# Access Compliance Report

## Public Rights-of-Way

### (Curb Ramps)

Intersection ID: 7225	Main Street: STATESVILLE_RD	Cross Street: STARITA_RD	Location: SE
ADA ID: 815808A1E064	Ramp Type: Para	Initial Pass/Fail: Fail	Overall Compliance: No
Severity Score: 13.75			
Codes/Mitigation Info/Possible Solution		Field Measurements/Component Compliance

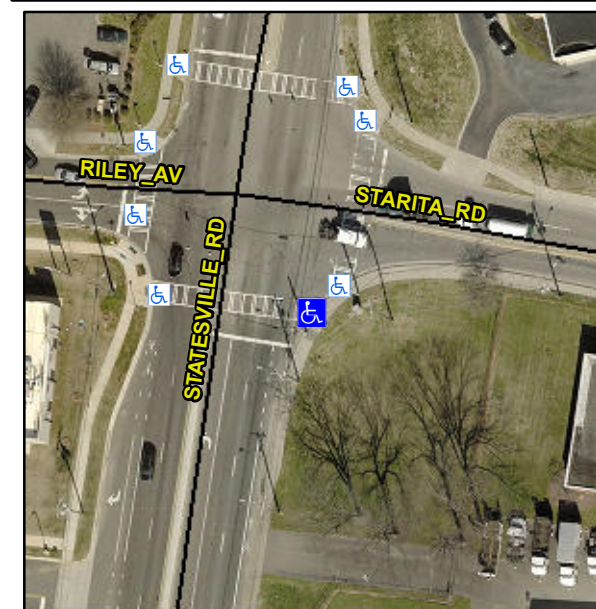
**R304.5.3, R304.3.2**

Compliance	Description	Data	Compliance	Description	Data
N/A	Ramp Length LT (in)	6.5	N/A	Ramp Length RT (in)	61.0
Yes	Ramp Width LT (in)	83.5	Yes	Ramp Width RT (in)	84.0
Yes	Ramp Slope LT (%)	5.9	No	Ramp Slope RT (%)	10.4
No	Ramp XSlope LT (%)	2.1	Yes	Ramp XSlope RT (%)	2.0
N/A	Landing Length (in)	N/A	N/A	DWS Provided?	N/A
N/A	Landing Width (in)	N/A	N/A	DWS Contrast?	N/A
N/A	Landing Slope (%)	N/A	N/A	DWS Length (in)	N/A
N/A	Landing X Slope (%)	N/A	N/A	DWS Full Width?	N/A
N/A	Landing Curb? (Y/N)	N/A	N/A	DWS Offset (in)	N/A
N/A	Shared Landing?	N/A			
N/A	Gutter Ponding?	N/A	N/A	Gutter Slope (%)	N/A
N/A	Gutter Lip Ht (in)	N/A	N/A	Gutter X Slope (%)	N/A
N/A	Painted X Walk1?	No	N/A	Painted X Walk2?	N/A
	X Walk 1 Direction	To W		X Walk 2 Direction	N/A
N/A	X Walk 1 Width (in)	N/A	N/A	X Walk 2 Width (in)	N/A
	X Walk 1 Slope (%)	2.8		X Walk 2 Slope (%)	N/A
	X Walk 1 X Slope (%)	0.6		X Walk 2 X Slope (%)	N/A
N/A	Ramp inside XWalk1?	N/A	N/A	Ramp inside XWalk2?	N/A

**Remove & Replace Entire Ramp.**
